March 4, 2019

Re: SUP 18-06 / Major Amendment for Lincoln Plaza Medical Center / 7125 E. Lincoln Drive.

# TAB 14

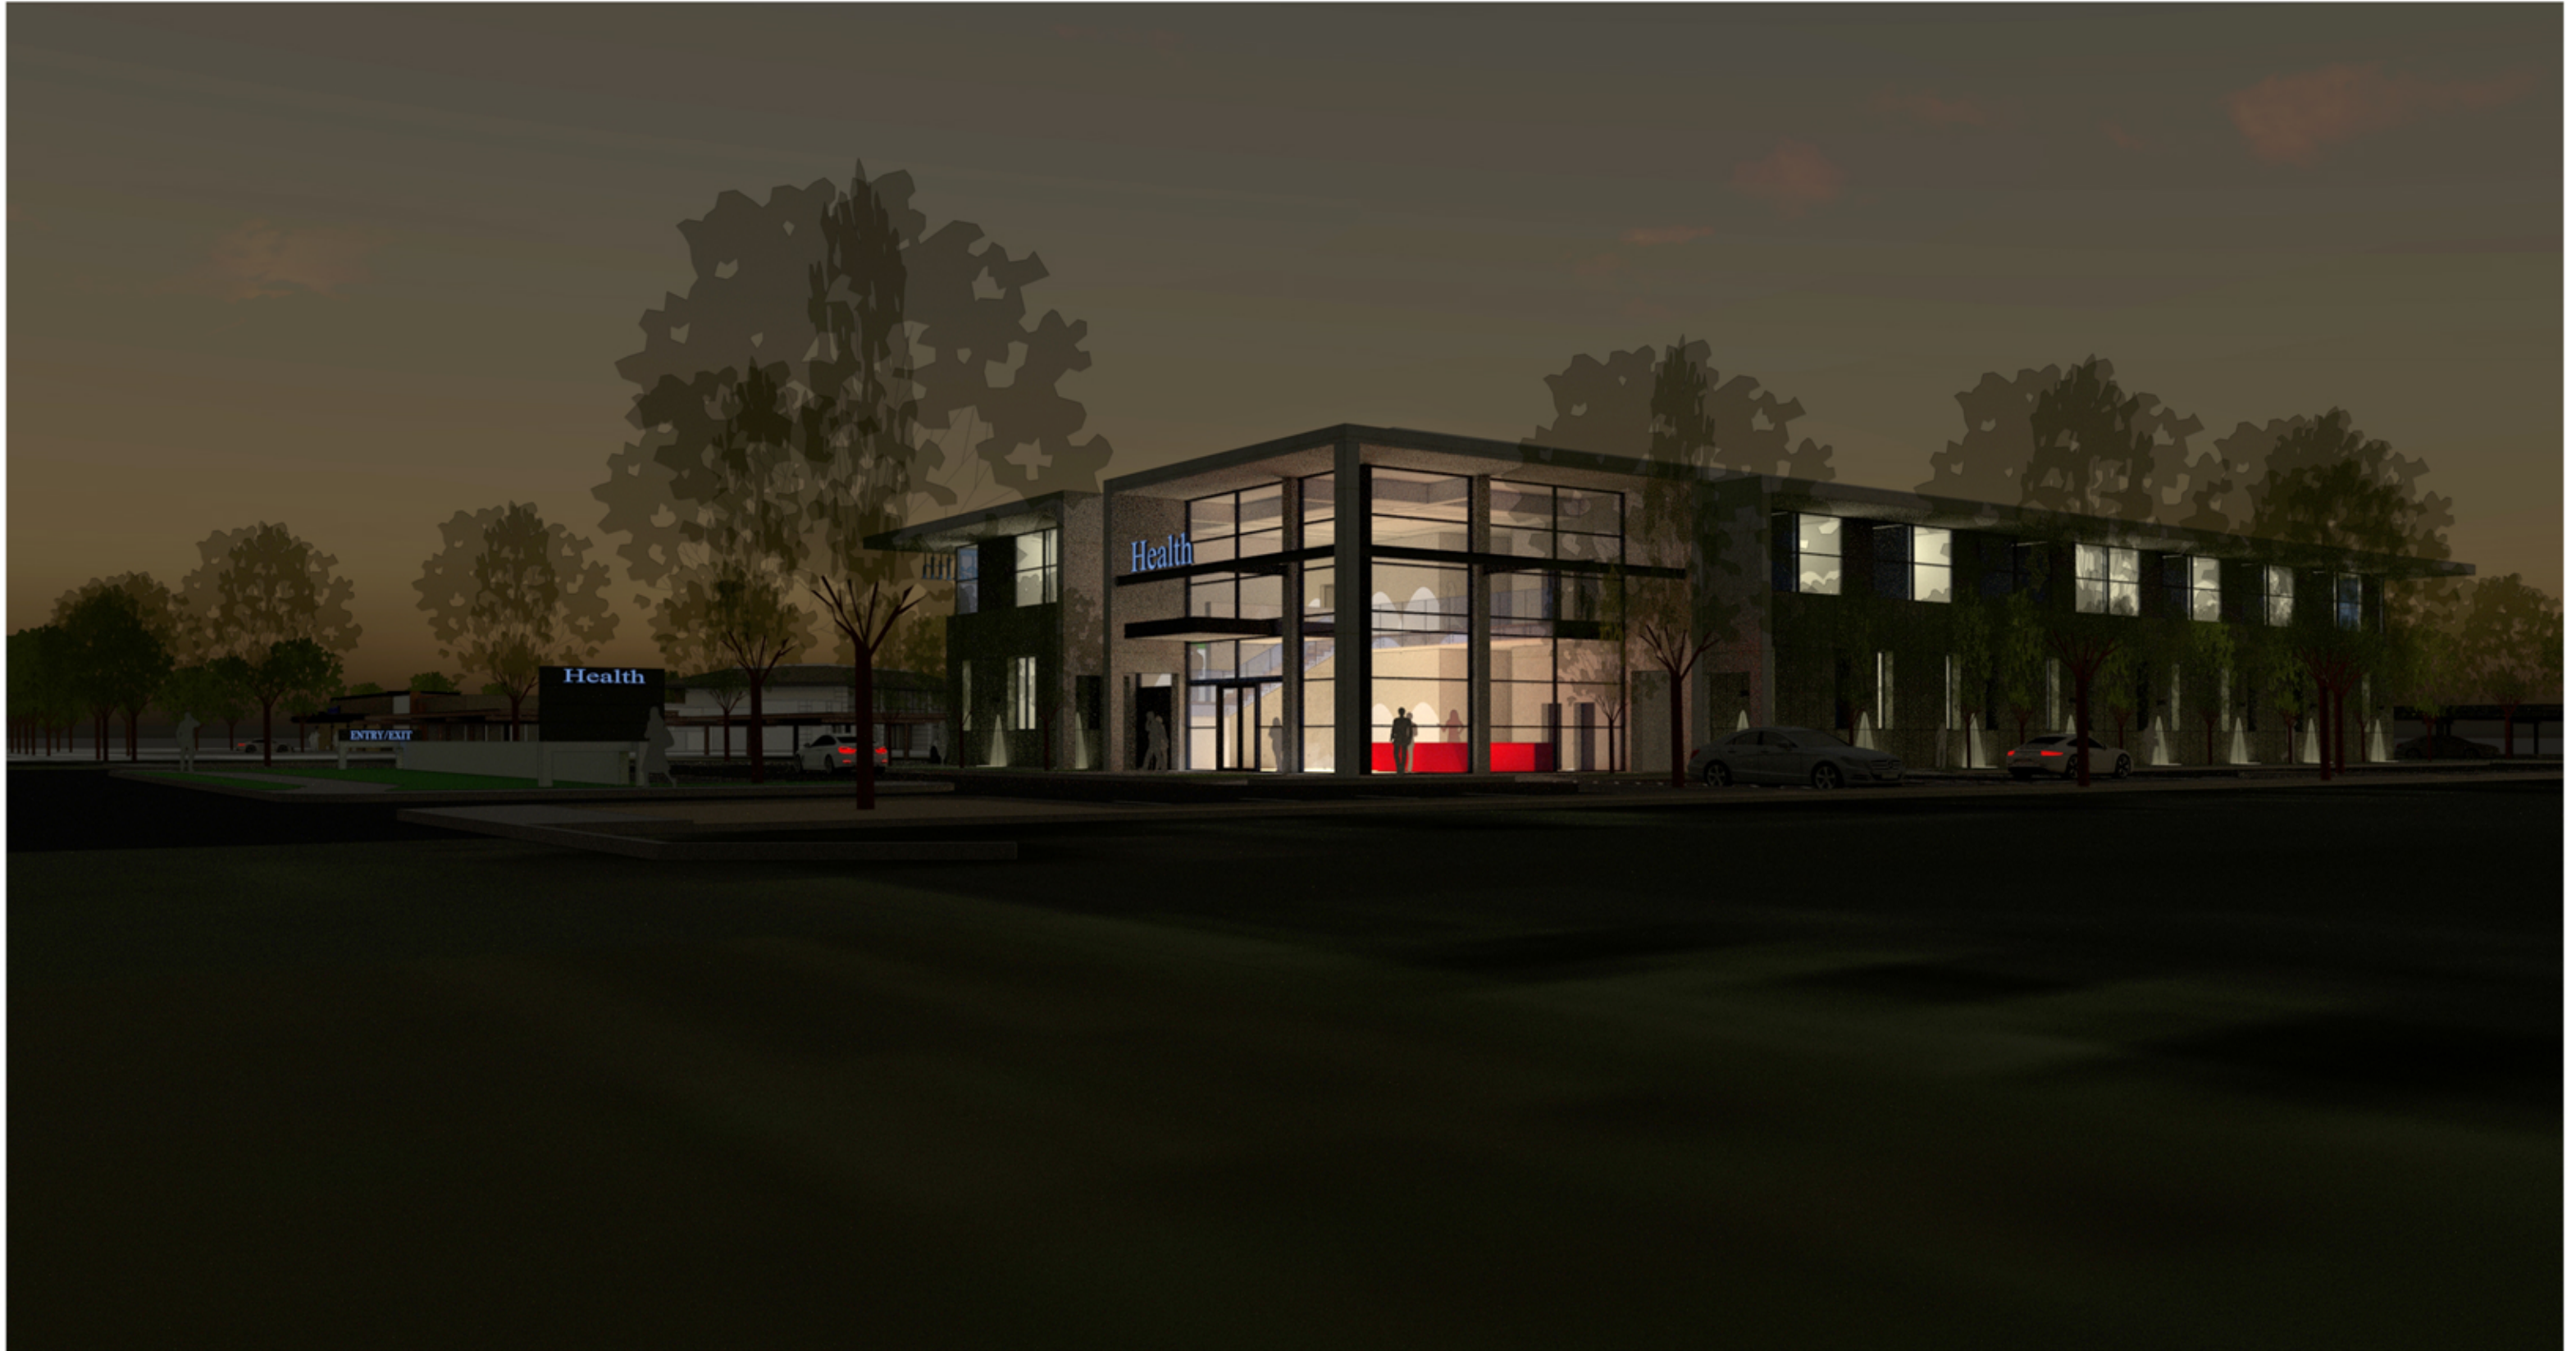
Finally, as the nighttime rendering attached at **Tab 14** illustrates, the lobby will be fitted with recessed down-lighting and other fixtures that will not project light outward. Lighting for the proposed medical office building – both indoor and outdoor – will not emit a meaningful level of ambient light beyond the property line. Any concerns with excessive illumination are already addressed by the proposed lighting plans and lighting stipulations in the draft SUP ordinance.
